Amendments to the Drawings

REMARKS

This Reply and Amendment is intended to be completely responsive to the Office Action dated May 5, 2005. Claims 1-34 are pending in this Application. Claims 12-14, 19, 22-24, 31-32 and 34 are currently withdrawn. Claims 1-11, 15-18, 20-21, 25-30 and 33 stand rejected. Claims 1-5, 8-11, 16-18, 20, 25, 27-28 and 30 have been amended. New FIGURE 3D has been added. The Specification has been amended to add new paragraph 0014.1 related to the addition of new FIGURE 3D.

FIGURE 3D

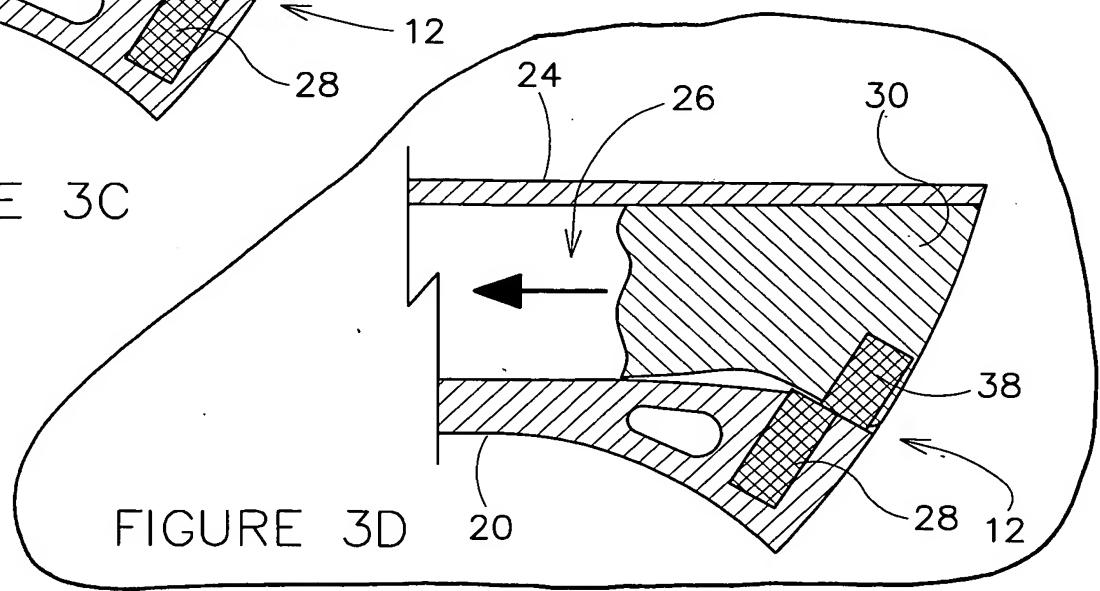
The drawing sheet 3/4 has been amended to add new FIGURE 3D, which shows one example of elements 28 and 38 to be arranged in an “offset” relationship. Appended to this Reply and Amendment is an annotated copy of the drawing sheet 3/4 which has been marked to show changes (i.e. the addition of new FIGURE 3D) presented in the replacement drawing sheet 3/4.

In Section 3 of the Office Action, the Examiner objected to the drawings because the “partially offset relationship” recited in Claim 18 must be shown or canceled from the claim.

The Applicants have added new FIGURE 3D which shows one example of a “partially offset relationship” and is supported by the Specification at (among others) paragraph 0021, lines 11-14.
